CITY OF LA VISTA
MAYOR AND CITY COUNCIL REPORT
OCTOBER 16, 2018 AGENDA

Subject:	Type:	Submitted By:
APPLICATION FOR PUD SITE PLAN – LOT 2, SOUTHPORT EAST REPLAT NINE (EAST OF SOUTHPORT PKWY & S 123 RD PLZ. INTERSECTION)	◆ RESOLUTION ORDINANCE RECEIVE/FILE	CHRISTOPHER SOLBERG CITY PLANNER

CASE NUMBER: PPUD-18-0004

RE: Planned Unit Development (PUD) Site Plan Amendment
Initial Review
Lot 2, Southport East, Replat 9

Attachment

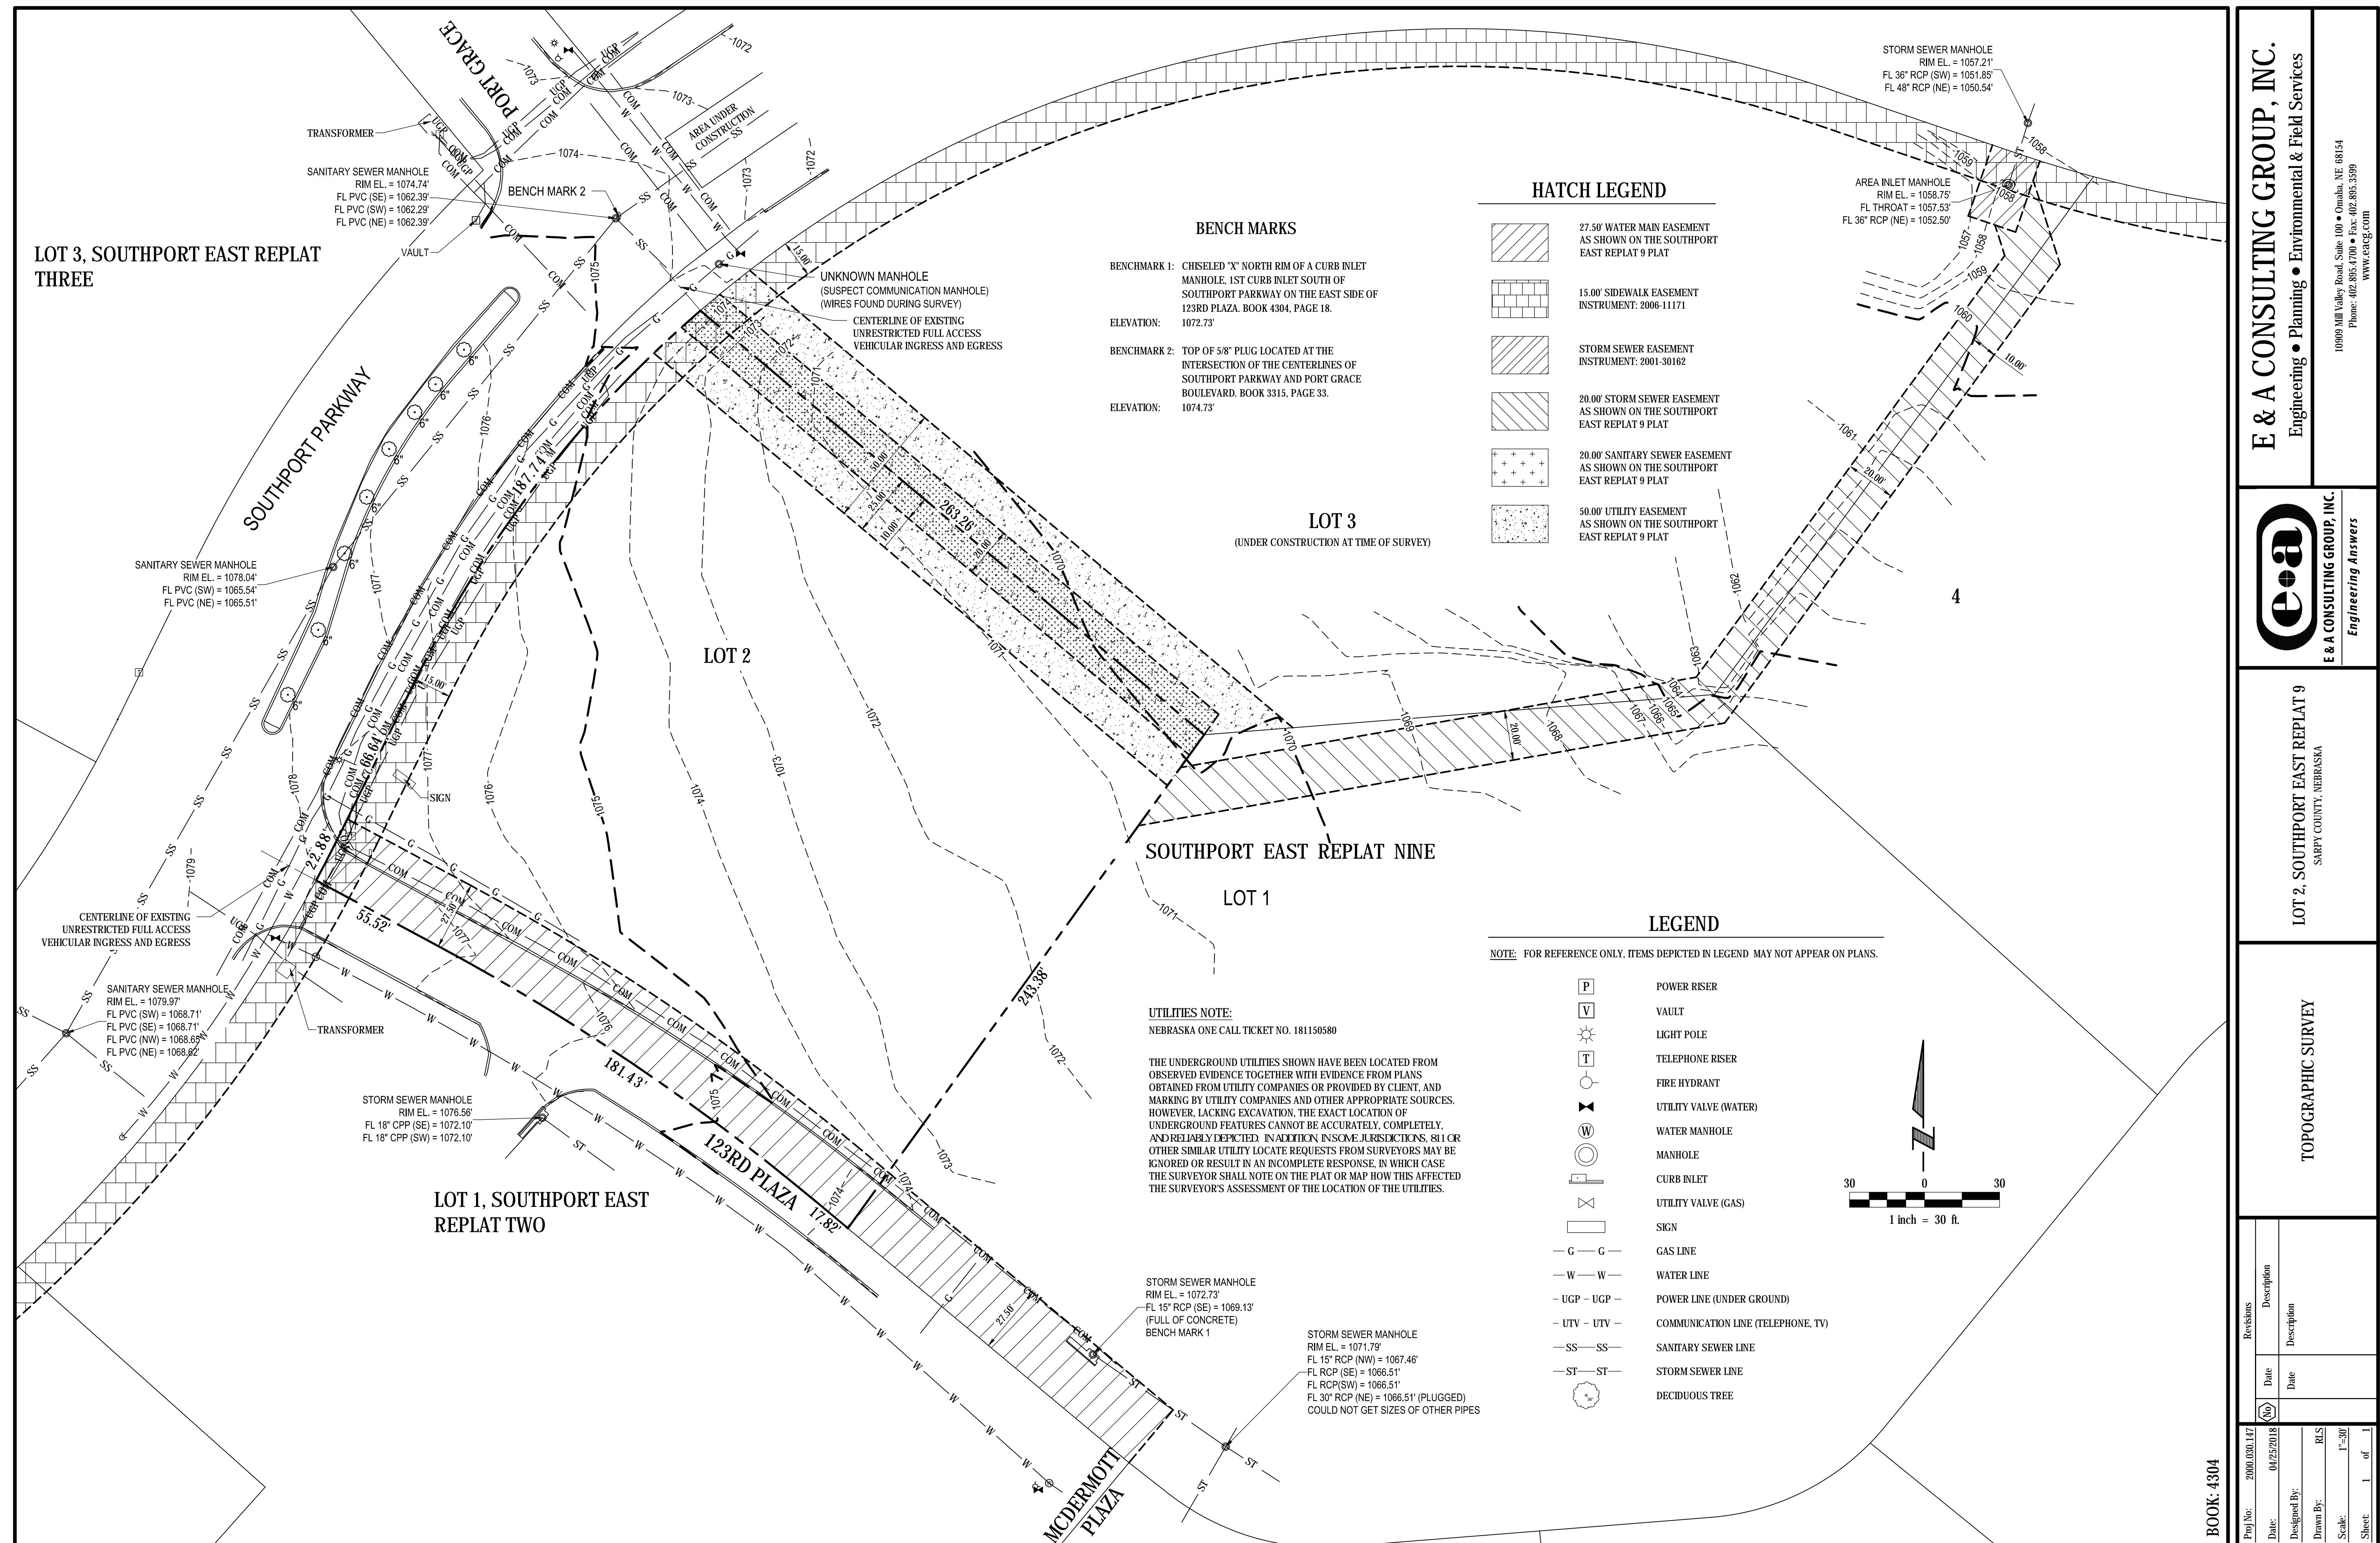
The PUD ordinance for this property requires a minimum greenspace requirement of 20%. The site plan provided depicts a greenspace percentage of 18.9%. Adjustments to the PUD site plan need to be made to increase this to the required 20%. Through rough calculations it is determined that this can be achieved by reducing the depth of the exterior-facing parking stalls along the NW, SW, and SE lot lines by two feet as per Section 7.17.05.05 (second paragraph). It appears that it can also be achieved by reducing the parking stalls to the minimum requirement of 94 stalls as noted in issue #5 above. Or some combination thereof.
